T-SB-0192-12

# Intermittent MIL "ON" DTC P0335

Some 2006 – 2012 model year vehicles equipped with the 2AZ engine may exhibit an intermittent MIL "ON" condition with Diagnostic Trouble Code (DTC) P0335 (Crankshaft Position Sensor "A" Circuit) stored. The intake camshaft gear assembly has been improved to help prevent this condition.

Figure 1.

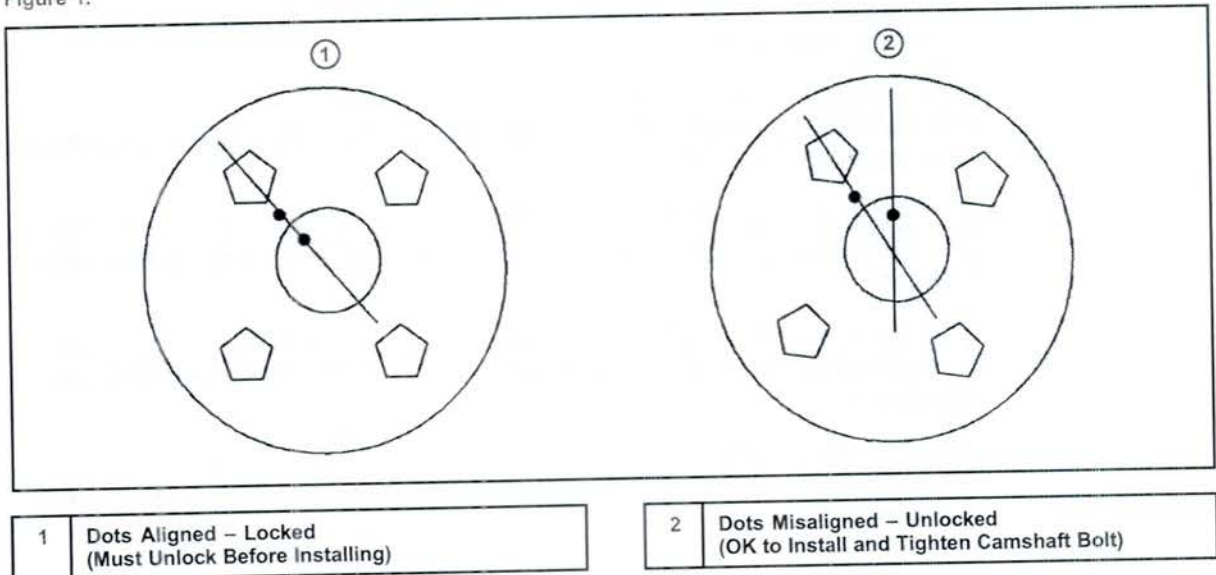
3. Identify whether the camshaft timing gear is unlocked or locked. (See Figure 1).

- If the camshaft timing gear is unlocked, it is ready to install.
- If it is LOCKED, follow the steps below to unlock the camshaft timing gear **before** installing.

Figure 2.

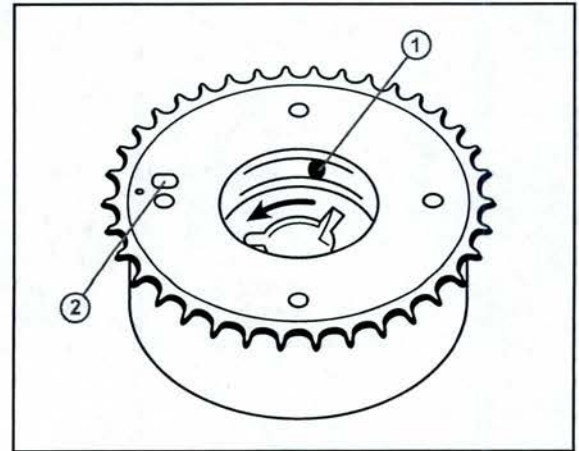
- A. To disengage the camshaft timing gear lock pin, apply and hold approximately 21 psi of air pressure at the oil feed hole located 90 degrees clockwise of the oval slot. (See Figure 2.)

**NOTE**  
 The lock pin is inside the gear, NOT the one located in the oval slot.

- B. With the 21 psi of air still applied to the gear, turn the interior assembly counterclockwise. (See black arrow in Figure 2.)
- C. Install the timing gear assembly onto the camshaft with the straight pin slightly to the right of the key groove as shown in Figure 3.

Figure 4.

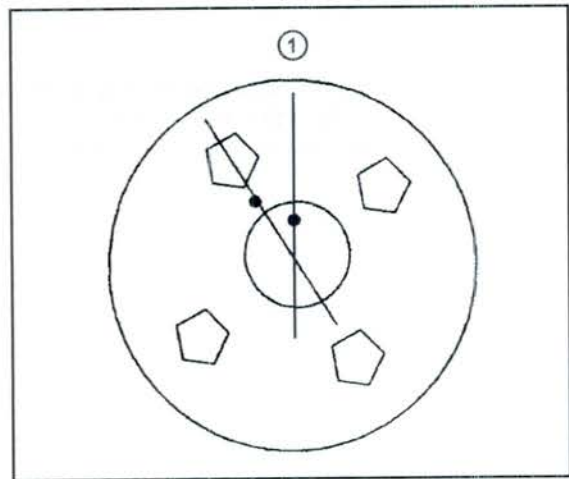
- E. Check that the camshaft timing gear is fully seated on the camshaft and that there is no clearance between the end of the camshaft and the timing gear. Install the camshaft bolt finger tight.

Check to make sure that the camshaft timing gear is still unlocked **BEFORE** tightening the camshaft bolt. The lock pin **MUST** be unlocked to prevent damage to the camshaft timing gear lock pin during tightening.

1	Dots Misaligned – Unlocked (OK to Install and Tighten Camshaft Bolt)
---	---

Figure 5.

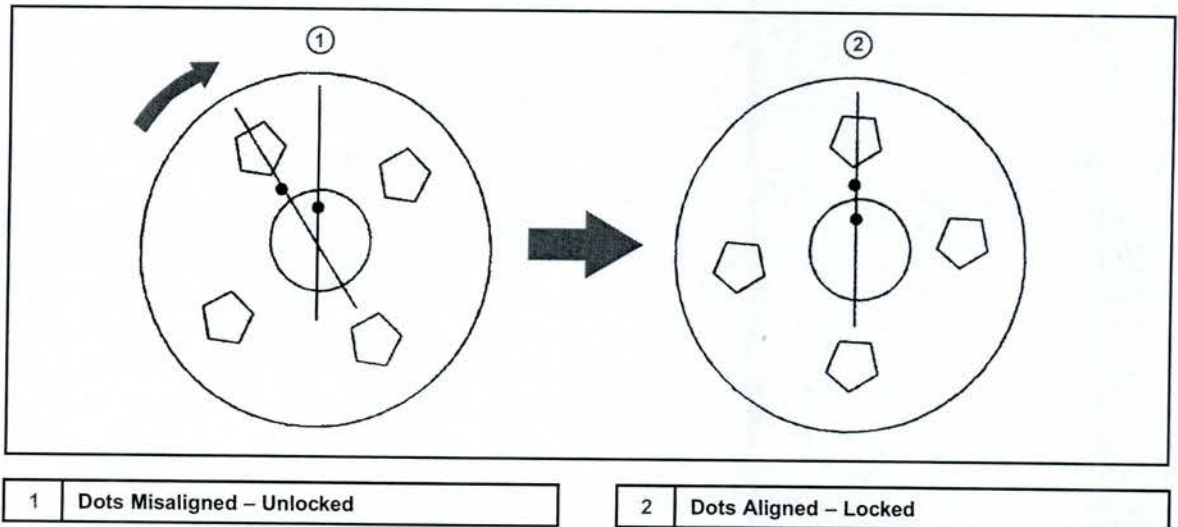
G. After torquing the camshaft bolt, rotate the camshaft timing gear clockwise while holding the camshaft stationary until the dots are aligned, to engage the camshaft timing gear lock pin.

**Camshaft timing is performed with the camshaft timing gear in the locked position (dots aligned).**
